PIC16F/LF1824/1828 Family

Silicon Errata and Data Sheet Clarification

The PIC16F/LF1824/1828 family devices that you have received conform functionally to the current Device Data Sheet (DS41419A), except for the anomalies described in this document.

FIGURE 1: INSTRUCTION CYCLE DELAY CALCULATION EXAMPLE

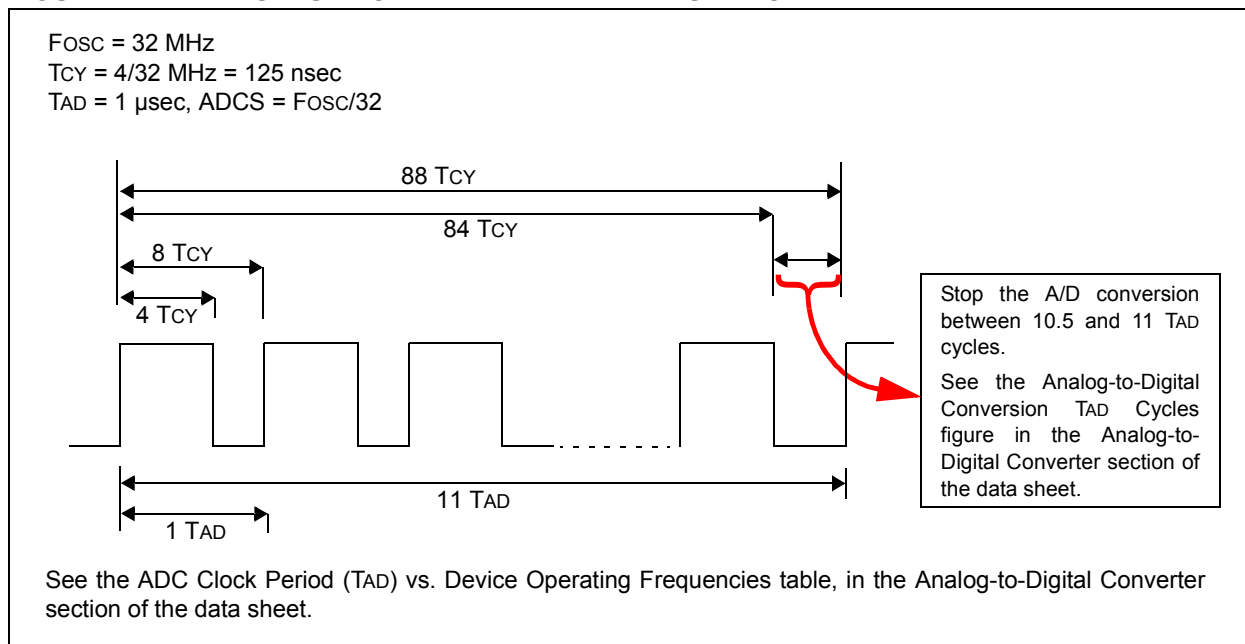
An ADC conversion may not complete under these conditions:

1. When Fosc is greater than 8 MHz and it is the clock source used for the ADC converter.
2. The ADC is operating from its dedicated internal FRC oscillator and the device is not in Sleep mode (any Fosc frequency).

When this occurs, the ADC Interrupt Flag (ADIF) does not get set, the GO/DONE bit does not get cleared, and the conversion result does not get loaded into the ADRESH and ADRESL result registers.

Method 3: This method is provided if the application cannot use Sleep mode and requires continuous operation at frequencies above 8 MHz. This method requires early termination of an ADC conversion. Provide a fixed time delay in software to stop the A-to-D conversion manually, after all 10 bits are converted, but before the conversion would complete automatically. The conversion is stopped by clearing the GO/DONE bit in software. The GO/DONE bit must be cleared during the last ½ TAD cycle, before the conversion would have completed automatically. Refer to Figure 1 for details.

In Figure 1, 88 instruction cycles (Tcy) will be required to complete the full conversion. Each TAD cycle consists of 8 Tcy periods. A fixed delay is provided to stop the A/D conversion after 86 instruction cycles and terminate the conversion at the correct time as shown in the figure above.

Note: The exact delay time will depend on the TAD divisor (ADCS) selection. The Tcy counts shown in the timing diagram above apply to this example only. Refer to Table 3 for the required delay counts for other configurations.
